**RE: NARRABRI UNDERGROUND MINE STAGE 3 EXTENSION PROJECT – TRANSPORT FOR NSW  
SUPPLEMENTARY SUBMISSION RESPONSES**

### TTPP CLARIFICATIONS ON VARIOUS MATTERS RAISED IN THE TFNSW SUPPLEMENTARY SUBMISSION

**RE: NARRABRI UNDERGROUND STAGE 3 EXTENSION PROJECT  
RESPONSE TO SUBMISSIONS – SUPPLEMENTARY SUBMISSION**

DWG No.		17380CAD001		
		FIGURE 1		
DATE STAMP		19 JULY 2021		
PROJECT No.	17380	SCALE	1:500 @A3	REV.
				A

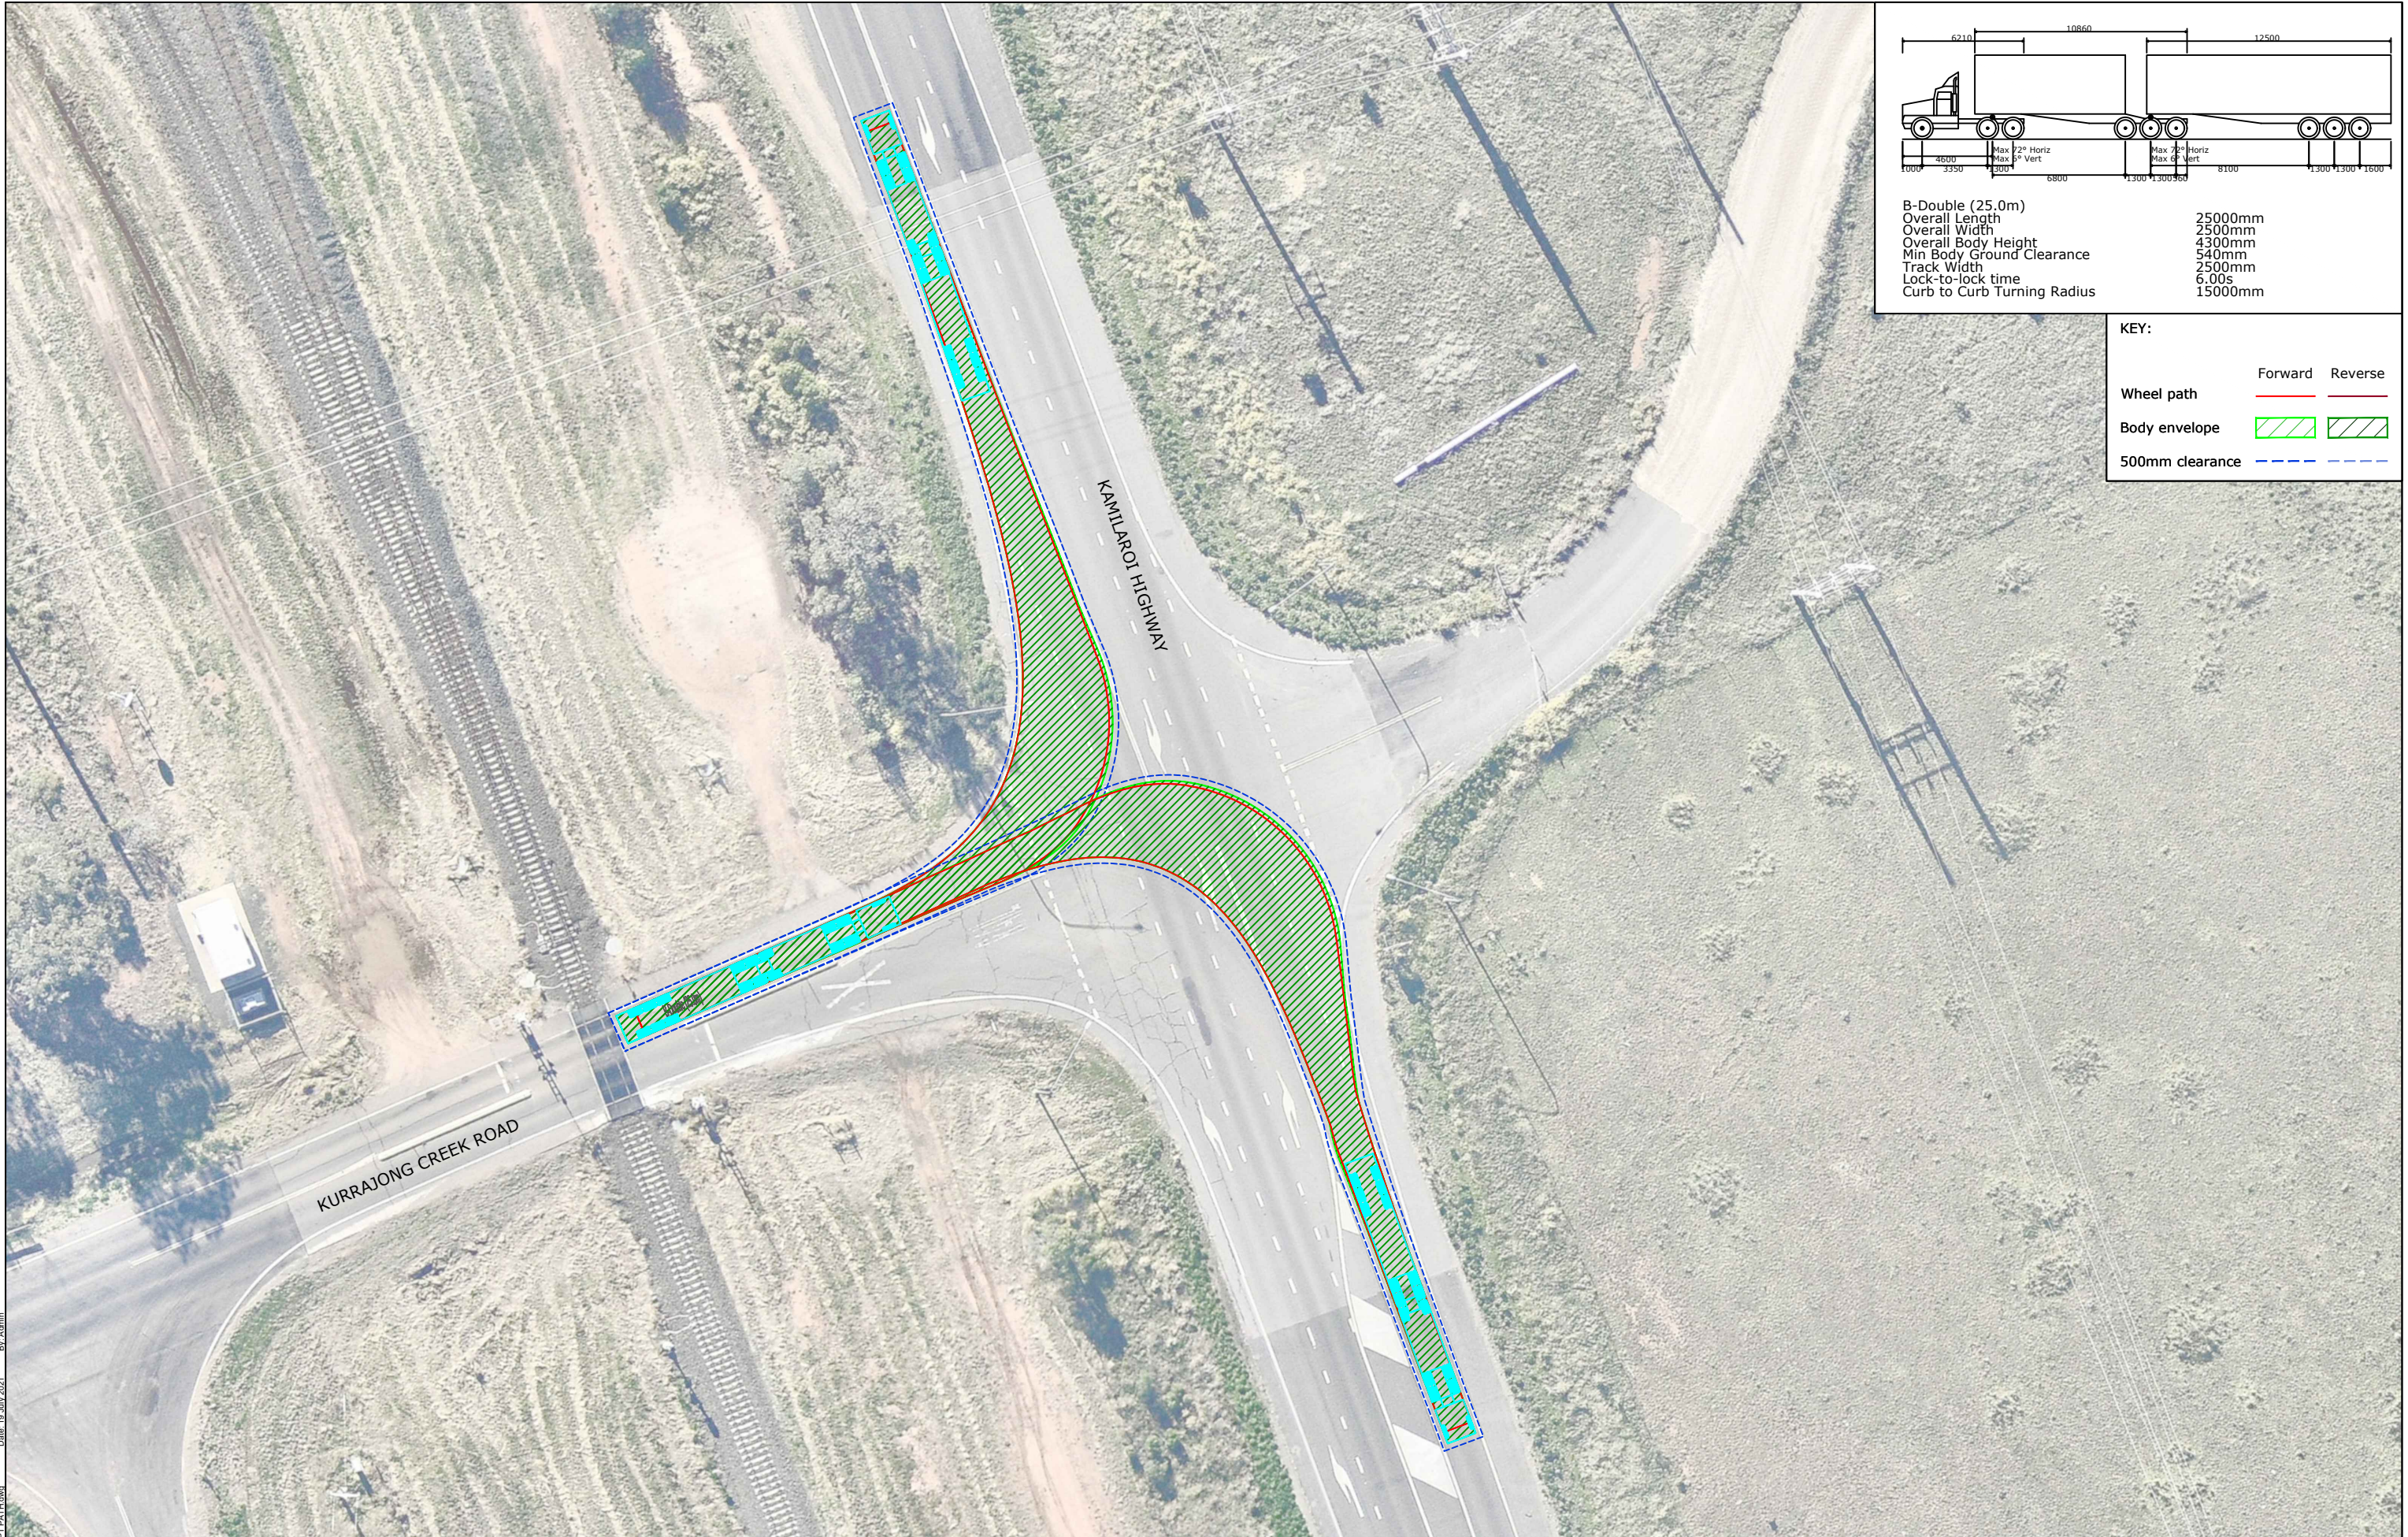
- *Please confirm the design vehicle (largest vehicle) accessing the site and provide swept path drawings demonstrating the design vehicle can safely turn in all four directions at the intersection of Kurrajong Creek Road with the Kamilaroi Highway. If upgrades would be required to safely cater for movements, specify the maximum truck size(s) sought under this SSD application and/or the recommended extent of upgrade works.*

The swept paths of B-doubles turning both left and right into and out of Kurrajong Creek Road at Kamilaroi Highway have been checked and are presented in Attachment One. This demonstrates that B-doubles can safely turn in all four directions at the intersection under its existing layout, while maintaining lane discipline. B-doubles turning left in to Kurrajong Creek Road are able to do so from the left lane of Kamilaroi Highway, noting that vehicles exceeding 7.5 m in length and displaying a "DO NOT OVERTAKE TURNING VEHICLE" sign are permitted to turn from the marked lane next to the left lane. No upgrades to the intersection would be required to accommodate B-doubles, which would be the largest truck to access the site.
